DEVELOPMENT REVIEW COMMITTEE (DRC) COMMENT REPORT

APPLICANT RESPONSES

INITIAL MEETING DATE: April 22, 2025
REISSUE DATE: May 16, 2025
APPLICANT: City of Fort Lauderdale
AGENT: Stephanie Toothaker, Esq., P.A.
PROJECT NAME: International Swimming Hall of Fame (ISHOF)
CASE NUMBER: UDP-S25010
REQUEST: Site Plan Level IV Request

New 220,120 square foot, 6-story building containing 31,394 Square Foot Office Use, 29,377 Square Foot Event Space, 18,512 Square Foot Museum, and 18,254 Square Foot Aquarium with an associated parking reduction request.

7. Sheet CD-101 (Demolition Plan):

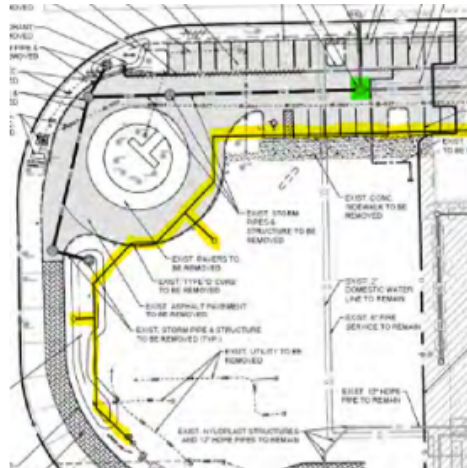
- b. Label disposition of what appears to be existing trees along west seawall, that may conflict with proposed improvements.

Response: Trees have been removed under permit LND-TREE-22070029. The revised sheet CD-101 no longer displays the existing trees.

8. Sheet SP-101 (Site Plan):

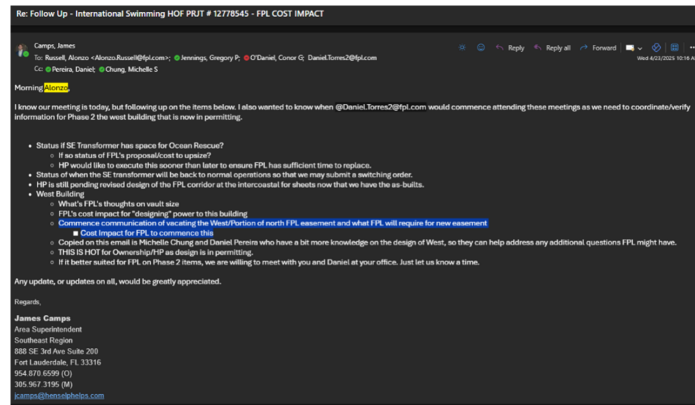
a. Delineate and callout all existing Florida Power & Light (FPL) easements in vicinity of 'Proposed 6-Story Building', including "18' F.P.L. Easement per O.R.B. 12157, PG. 486, B.C.R.", "10' F.P.L. Easement per O.R.B. 27026, PG. 661", and "Easement Area Permit #115940588", as depicted on 'Map of ALTA Survey'.

Response: Easements have been identified and called out on SP-101 per the Map of Alta Survey. Please see revised Sheet SP-101.

Snip from SP-101 Reflecting Portion of FPL Easement that is being coordinated to Vacated/Rerouted:

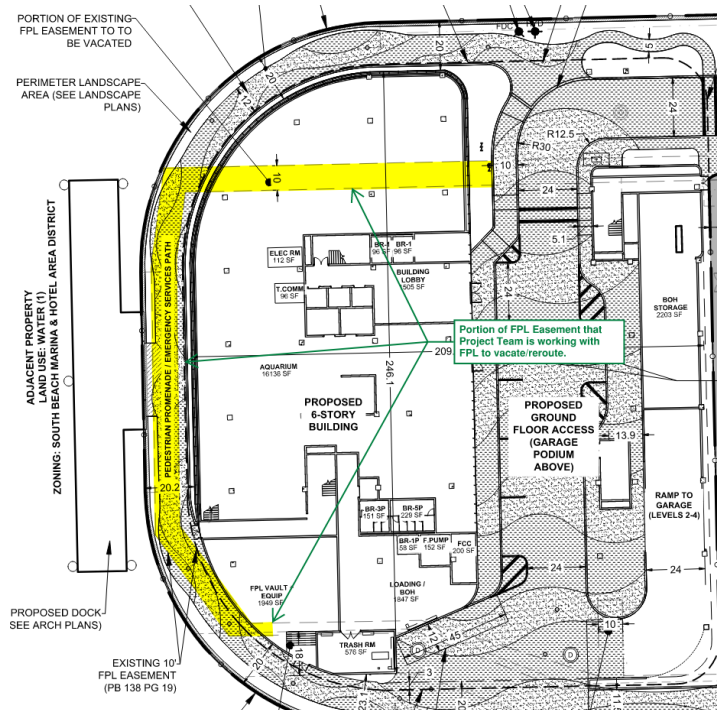
i. Regarding the 'Portion of Existing FPL Easement to be Vacated' callouts, show/label approximate limits of FPL easements to be vacated, and provide PDF copy of written correspondence from FPL staff that they have no objection to proposed vacations.

Response: HP has been in consistent communication with FPL on the potential of vacating a portion of the West and North easements on the west end of the peninsula, see attached image of email communication and marked up drawings. FPL is currently reviewing the loads for the future building as well as the revised pathways for their easement. Once this has been coordinated with FPL, the updated drawings will be reflected.
